# UNITED STATES PATENT AND TRADEMARK OFFICE

10/771,289

<b>Office Action Summary</b>	<b>Application No.</b> 10/771,289	<b>Applicant(s)</b> MEZIERE ET AL.	
	<b>Examiner</b> LESLIE R. DEAK	<b>Art Unit</b> 3761

## **DETAILED ACTION**

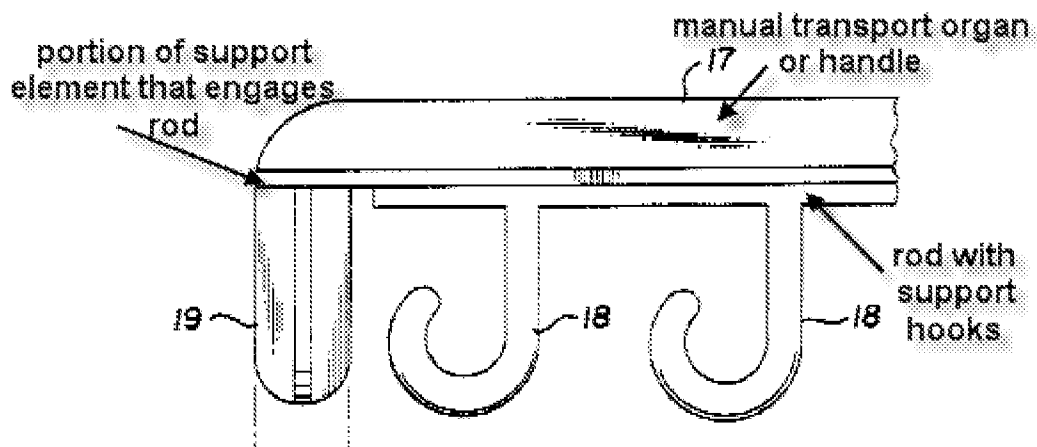
With regard to claims 8-13, 24, the support elements comprise a body or rod that carries a top section that may be used as a manual transport organ or handle to rotate the support elements or arms. The body or rod further comprises hooks 18 and is connected to the support element. See Belokin FIG2, as annotated by the Examiner, below.
